**CONSTRUCT T-HANGAR & T-HANGAR TAXILANES**  
**FOR THE WARSAW MUNICIPAL AIRPORT**  
**CONTRACT NO. 17-023A-1**  
**ADDENDUM NO. 2**

April 27, 2018

Addendum No. 2 consists of the following clarifications, changes, additions, etc.

project	102431	MoDOT Proj No.	17-023A-1
drawing	G-002 - 0		
sheet	3	of	24 sheets
file	102431G-002.dwg

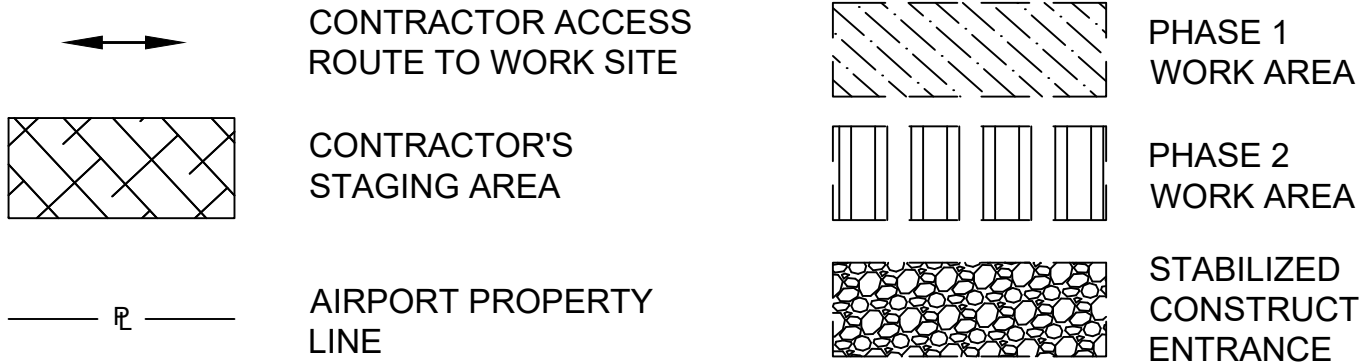
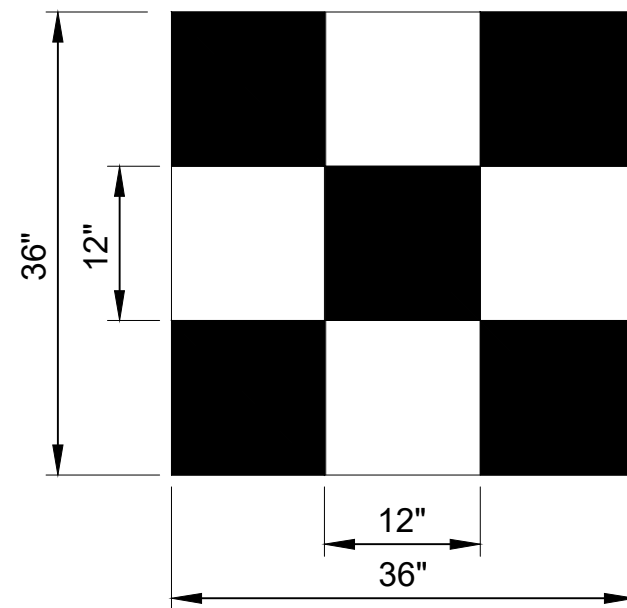
6. Does the electrical service have 2 meter sockets?

The existing meter has one meter socket which also contains meter breakers in the same individual enclosure. Connect to existing meter per Sheet G-002 and coordinate with the utility company.

- SEE DRAWING G-003 FOR ACCESS AND SAFETY NOTES.
- CONTRACTOR SHALL INSTALL SIGN(S) STATING "NO CONSTRUCTION TRAFFIC ALLOWED ON ACTIVE APRON/TAXIWAYS/ RUNWAY" PAYMENT SUBSIDIARY TO TRAFFIC CONTROL.
- PROVIDE 100A BREAKER IN EXISTING METER CABINET ON NORTH HANGAR.
- ROUTE 3-#2AWG AND 1-#8GND IN 2"C. FROM 100A BREAKER IN EXISTING METER AT NORTH HANGAR TO METER ON PROPOSED HANGAR. SEE DRAWING E-401 FOR MORE INFORMATION.
- ALL EXISTING TAXILANES SHALL REMAIN OPEN. CONTRACTOR SHALL DIRECTIONALLY BORE UNDER EXISTING PAVEMENTS. NO OPEN TRENCHING ACROSS EXISTING PAVEMENT SHALL BE ALLOWED.
- CONTACT UTILITY FOR ALL ELECTRICAL REQUIREMENTS.  
CO-MO ELECTRIC CO-OP  
PHONE: 660-433-5521

project	102431	MoDOT Proj No.	17-023A-1
drawing	<b>C-503</b>		
sheet	16	of	24 sheets
file	102431C-500.dwg

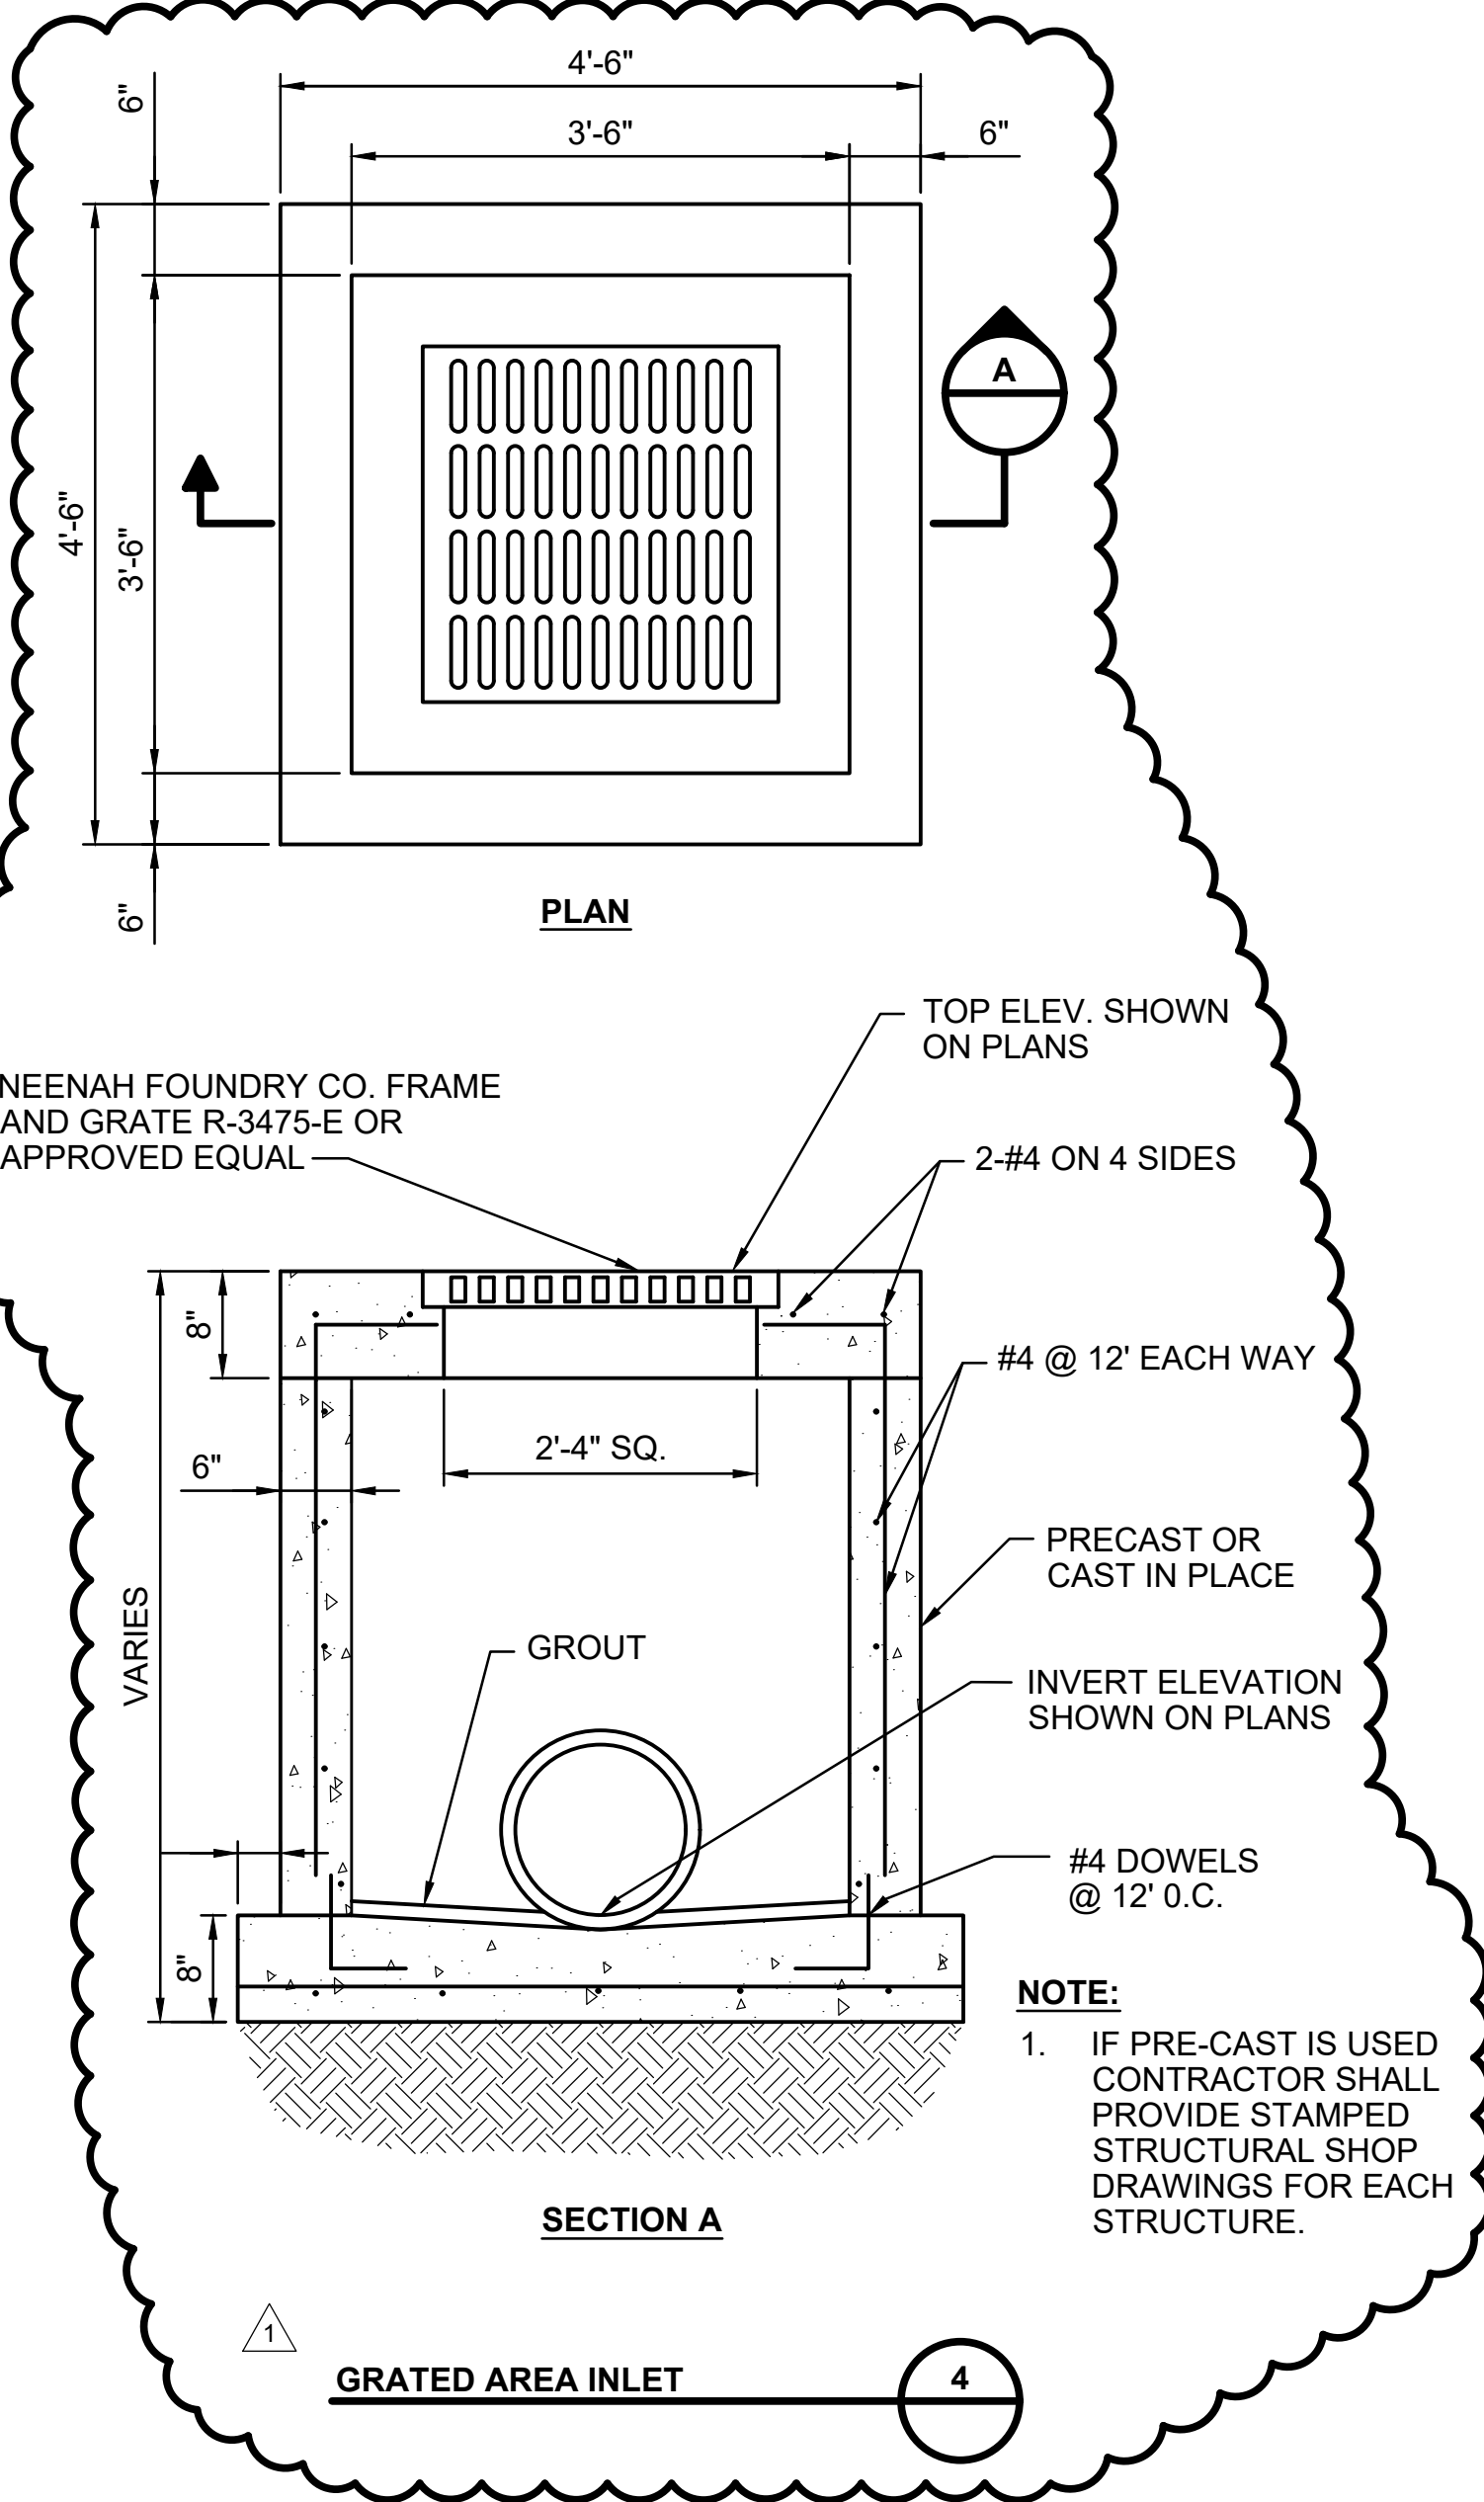
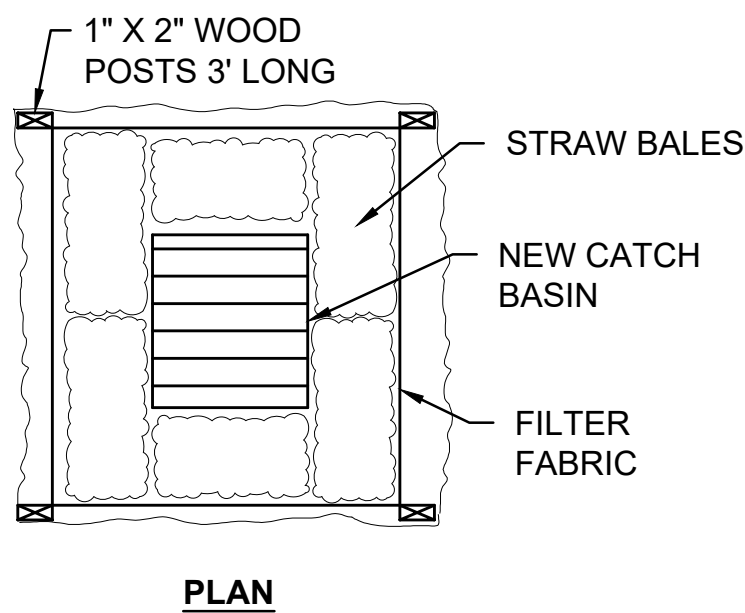
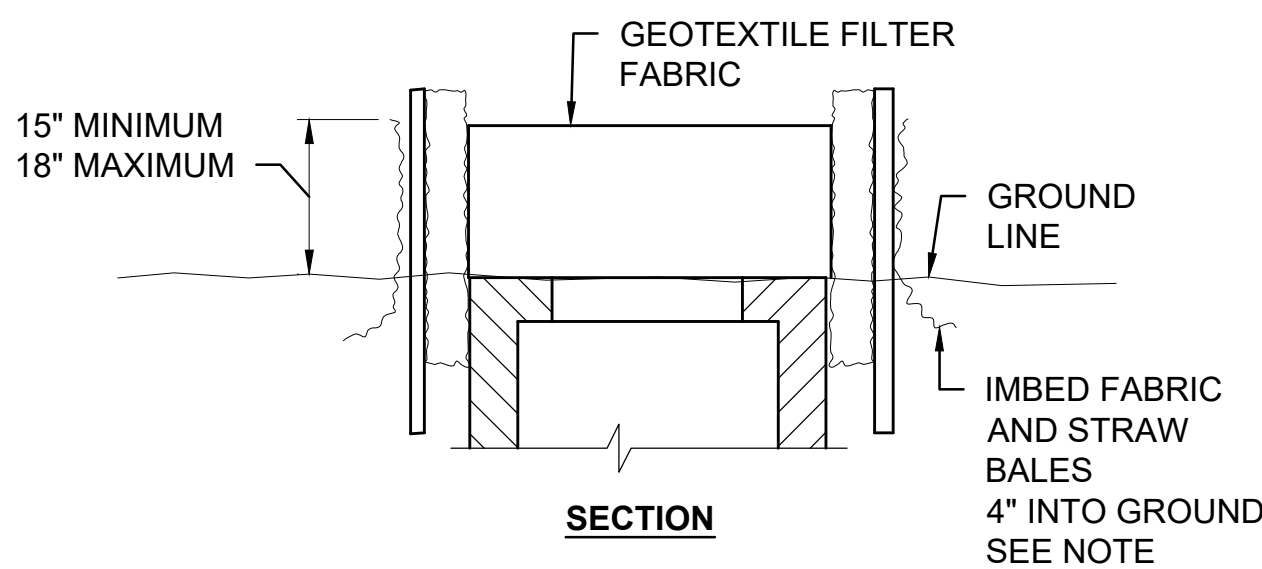
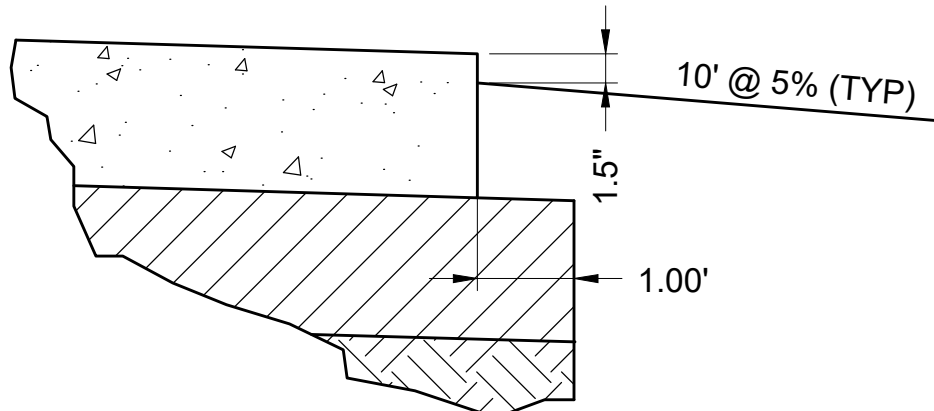
5. What size is the precast storm inlet-1?

Detail 4 on Sheet C-503 has been revised to provide additional information regarding the inlet, including the size.
